PLANNING NMA

Eton House | Explore
18-24 Paradise Rd, Richmond TW9 1SE

Rev 01

1 Consented vs Proposed Drawings

1.3 Consented - L01 Plan

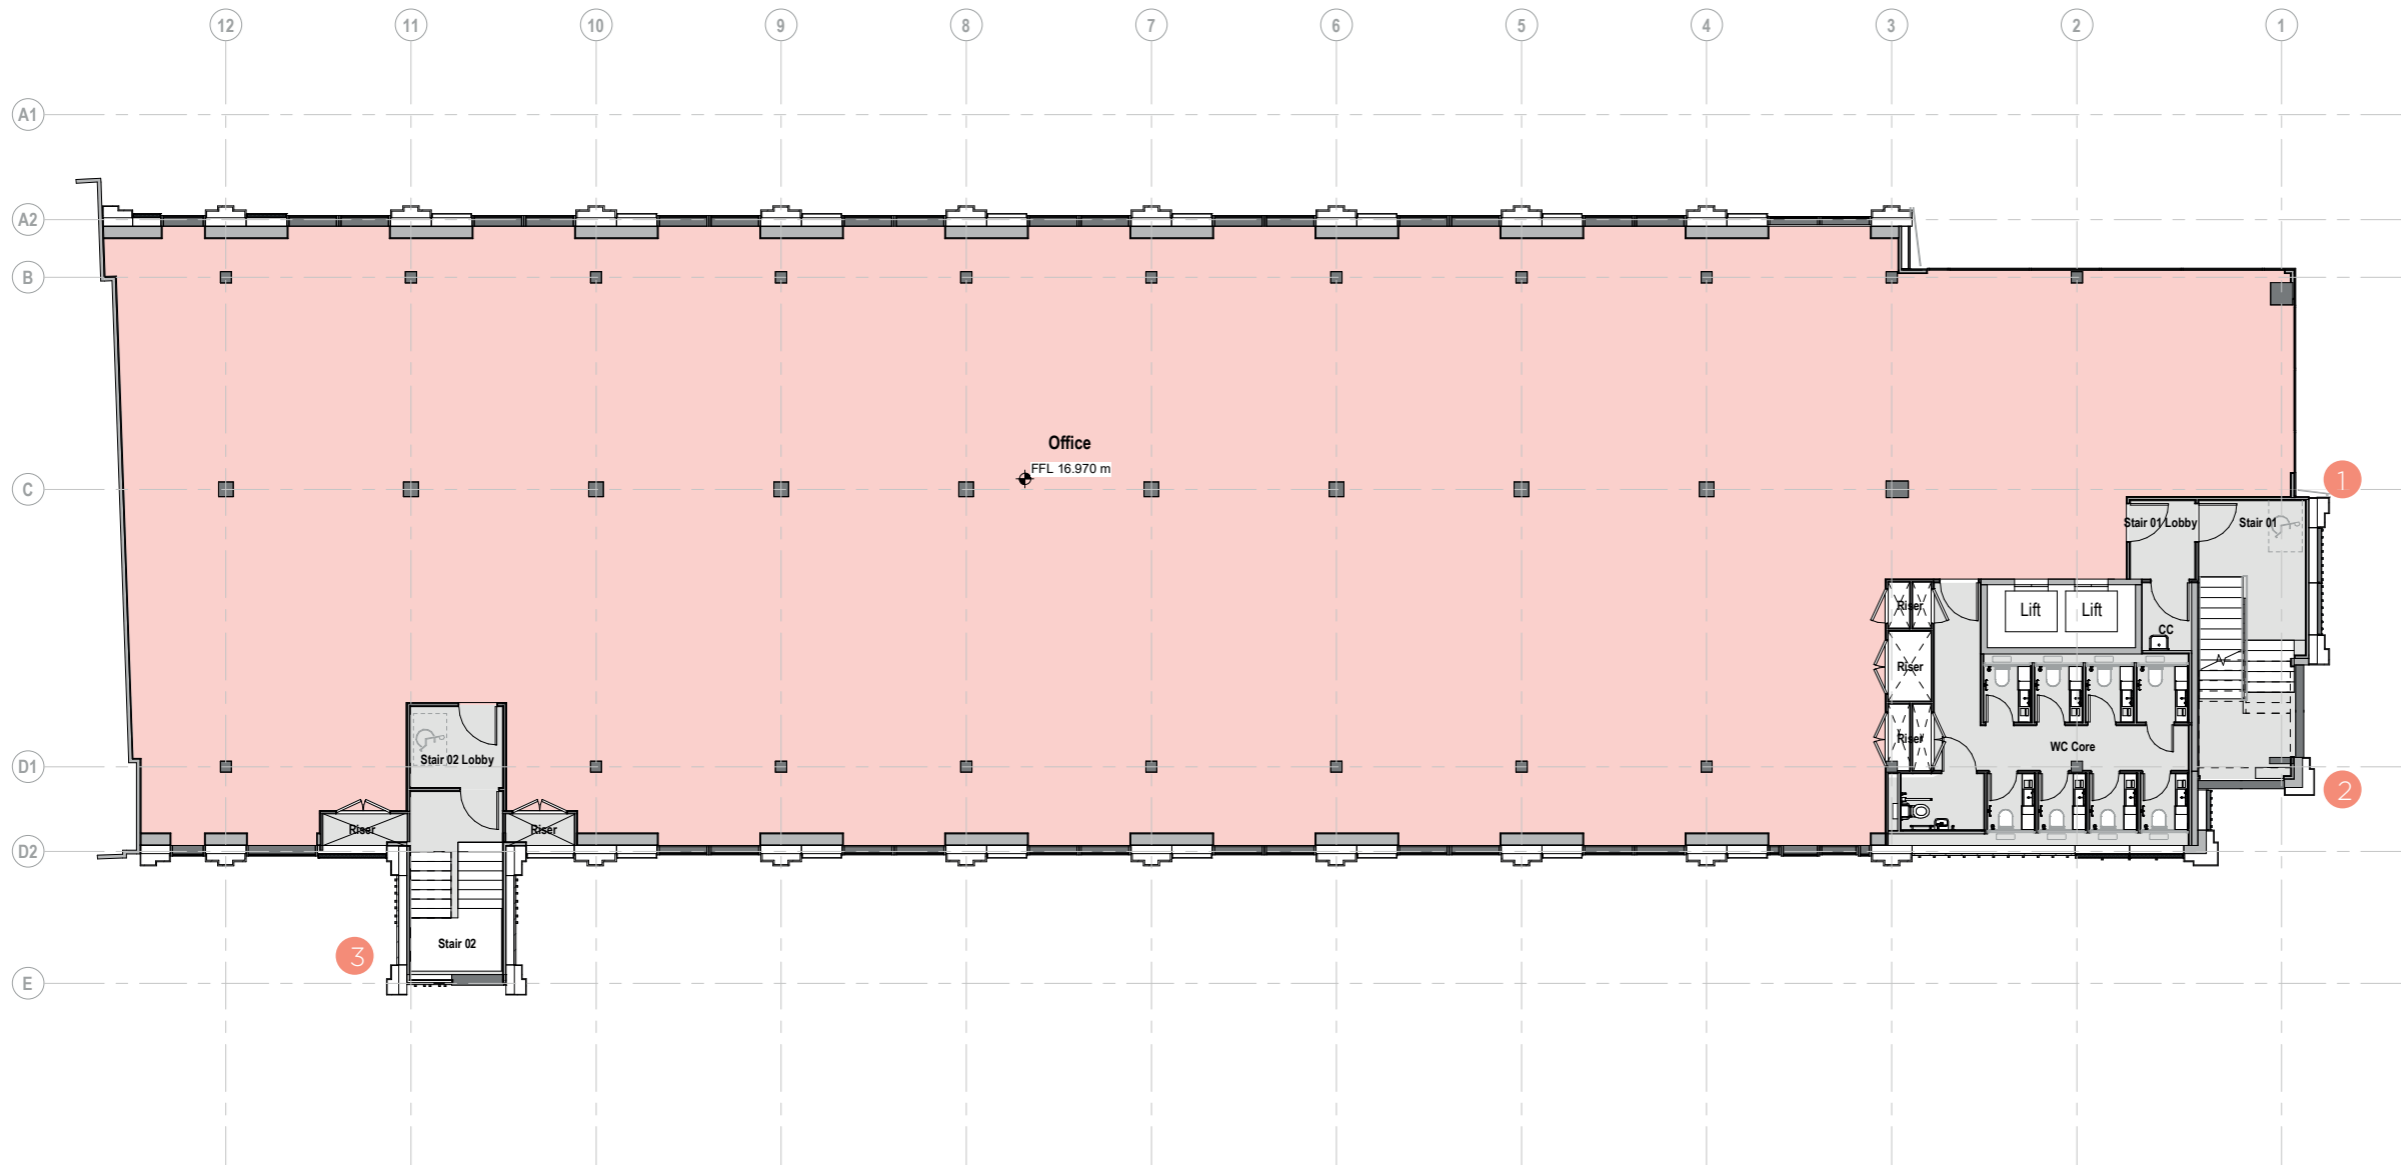
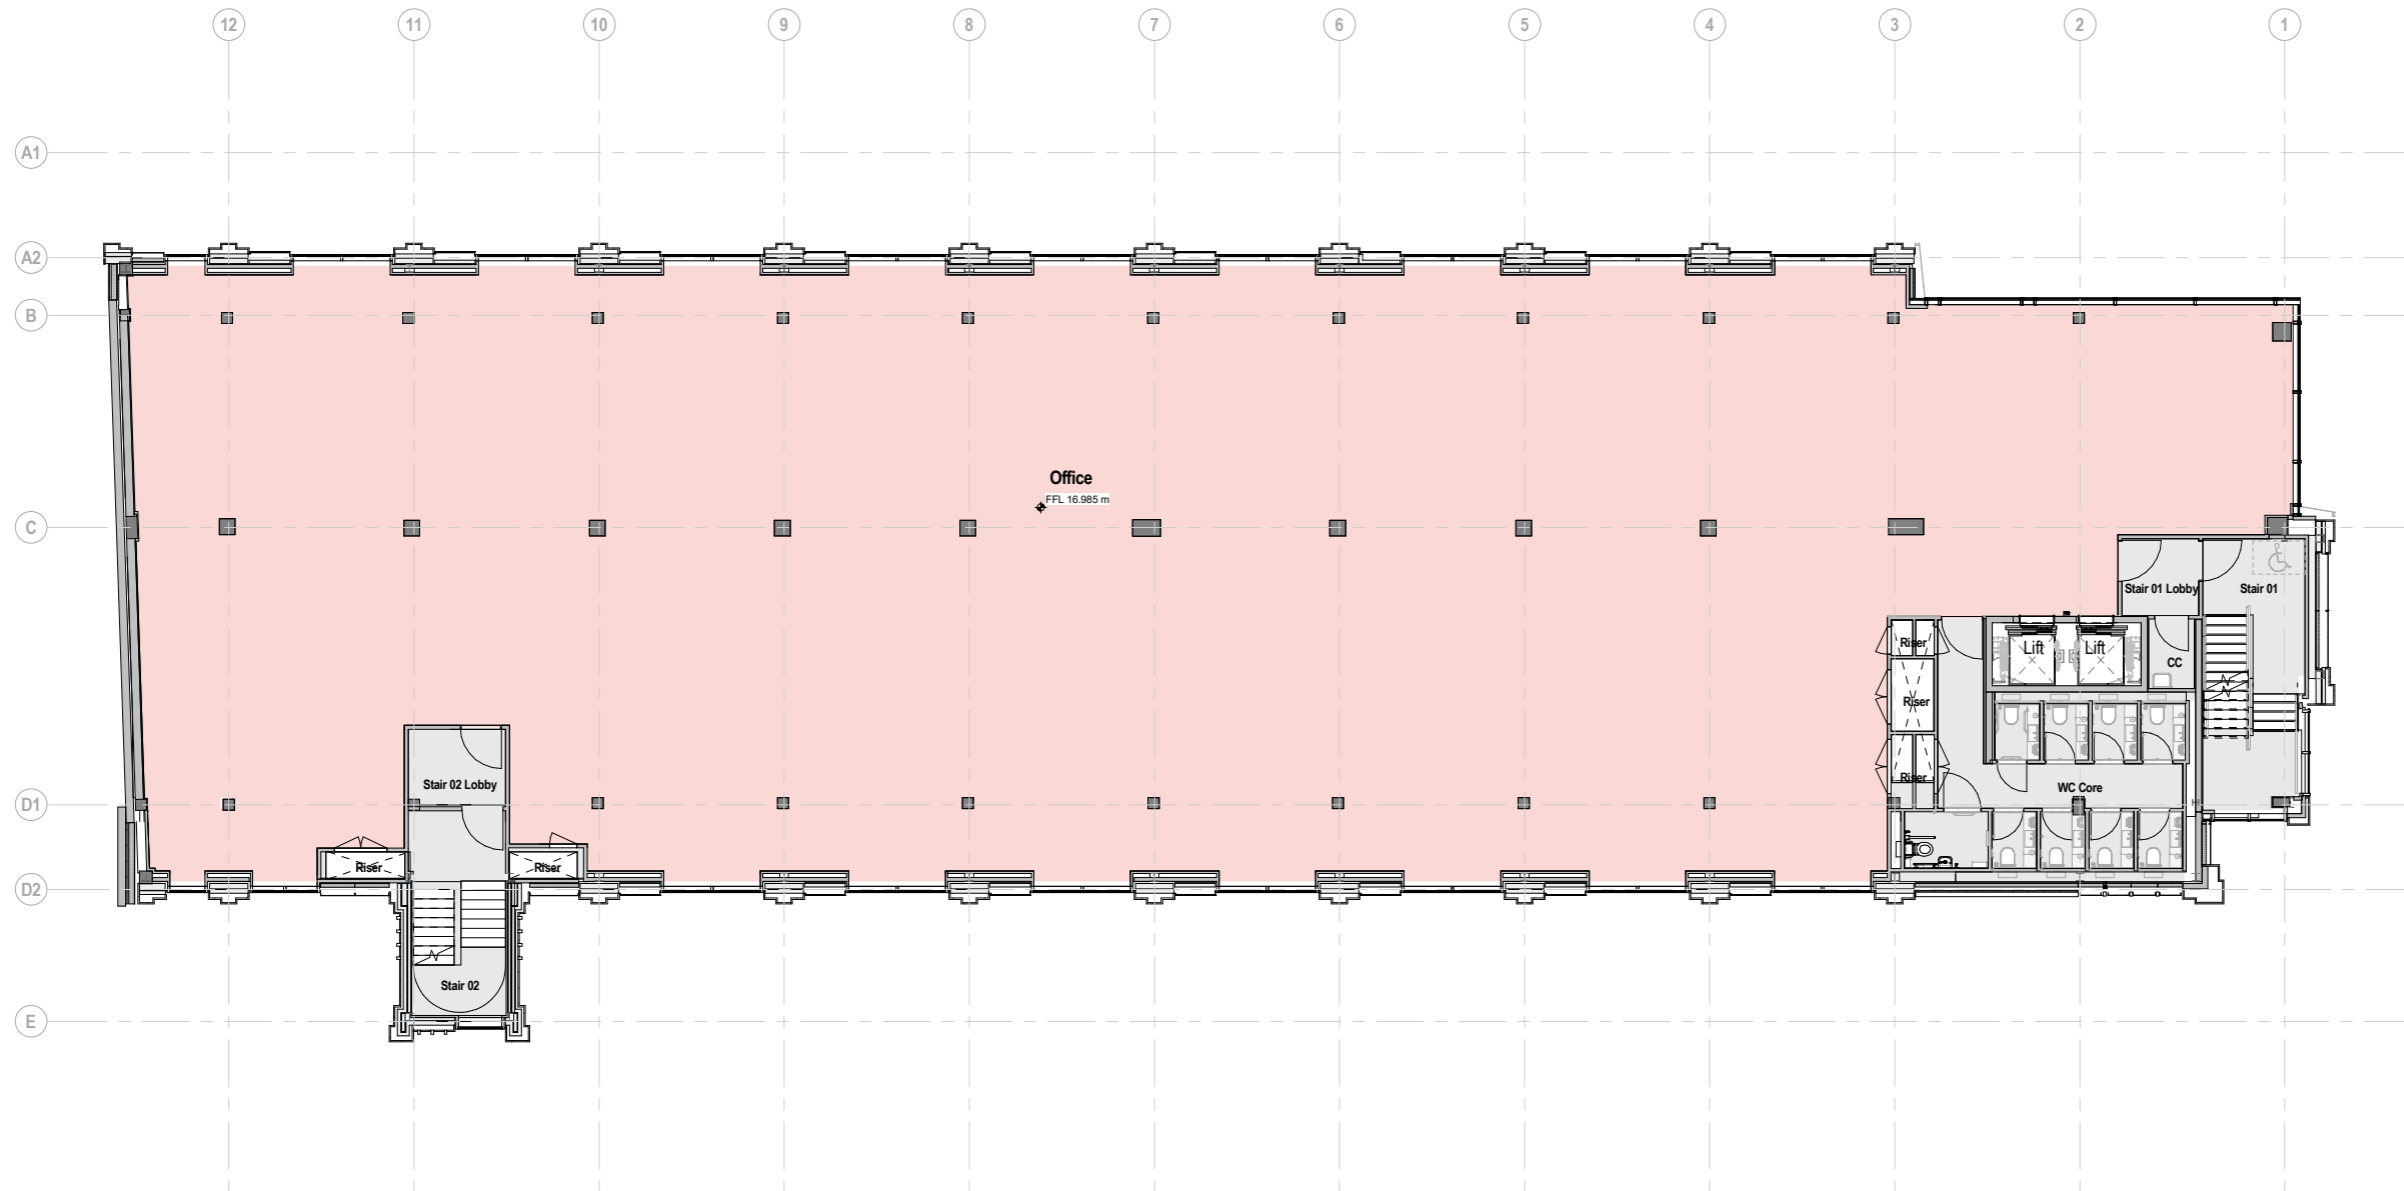
- 1 Marginal adjustment to wall position to suit existing structural discovered during detailed survey
- 2 Corner pier adjusted to avoid cross past boundary line
- 3 Number of fins reduced due to buildability constraints and to appear less cluttered.

1.5 Consented - L02 Plan

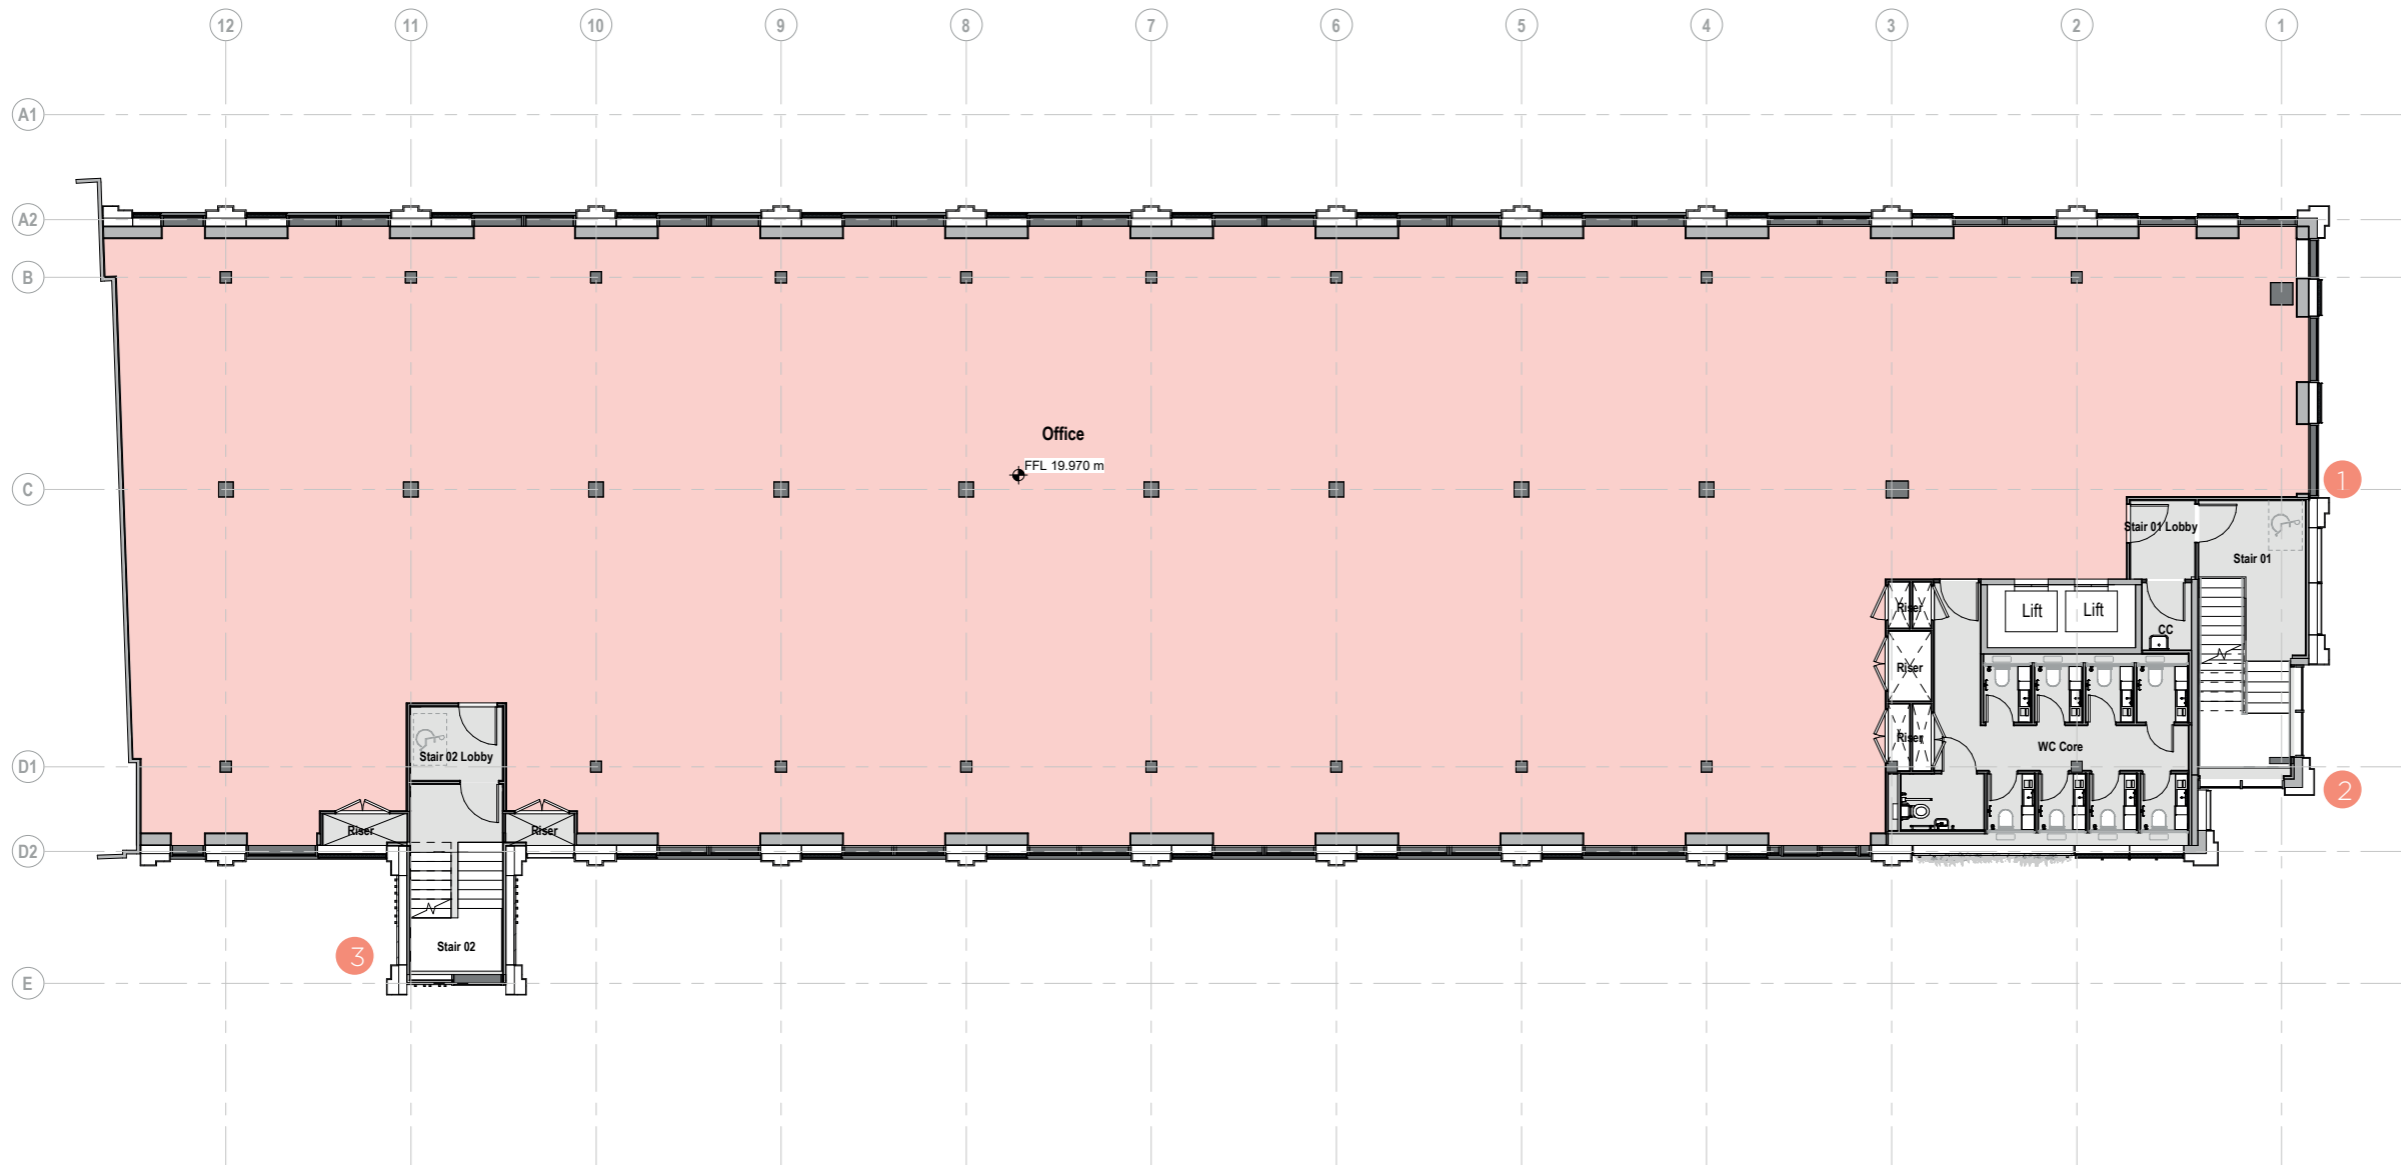
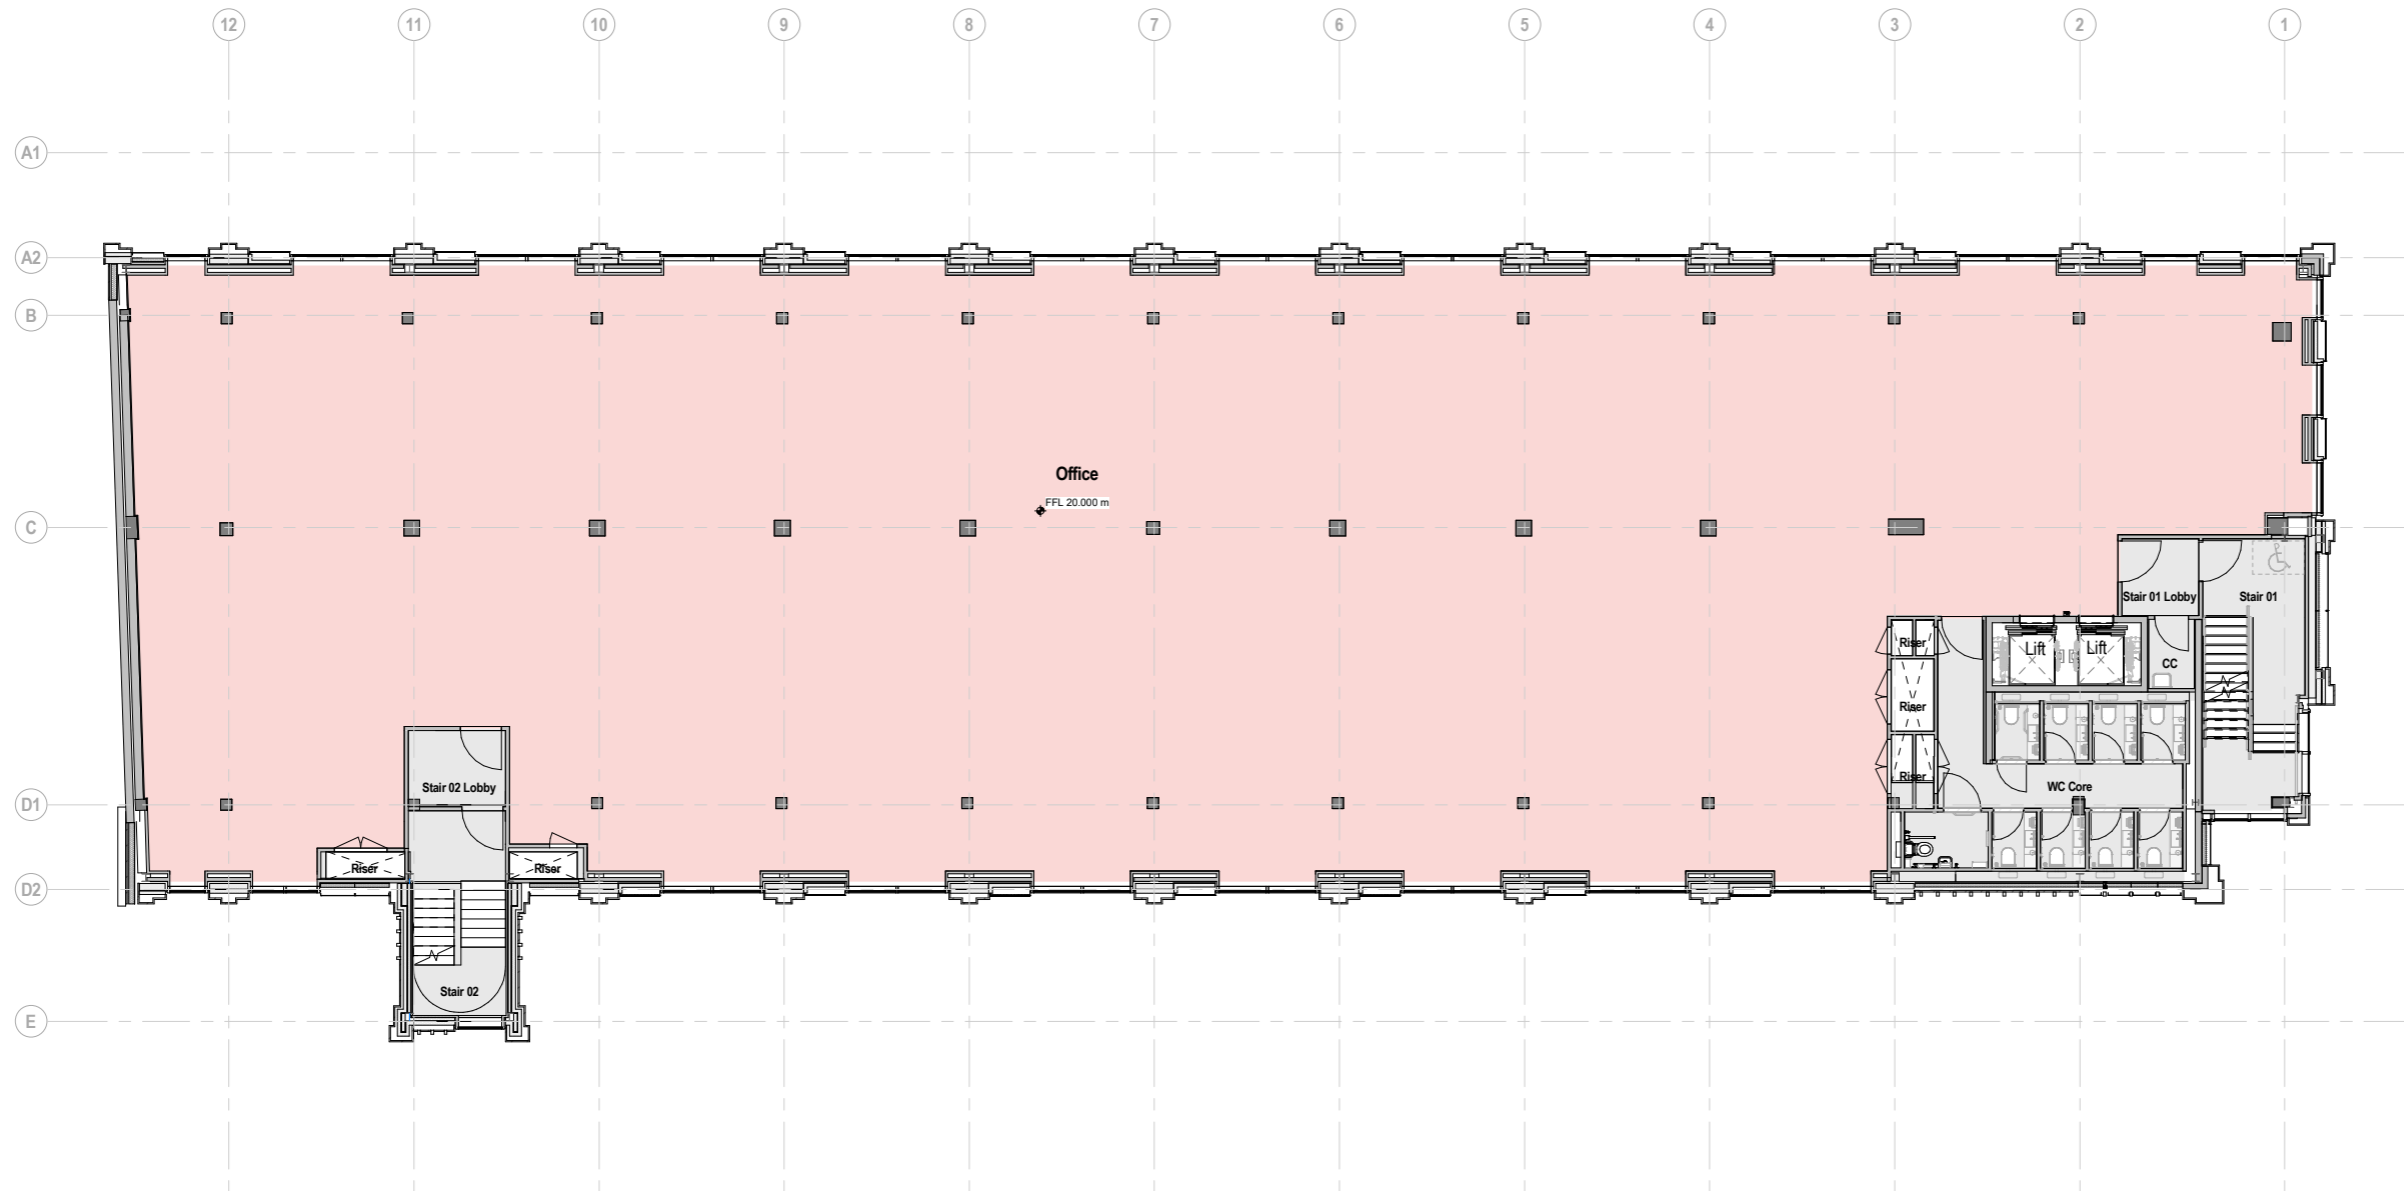
- 1 Marginal adjustment to wall position to suit existing structural discovered during detailed survey
- 2 Corner pier adjusted to avoid cross past boundary line
- 3 Number of fins reduced due to buildability constraints and to appear less cluttered.
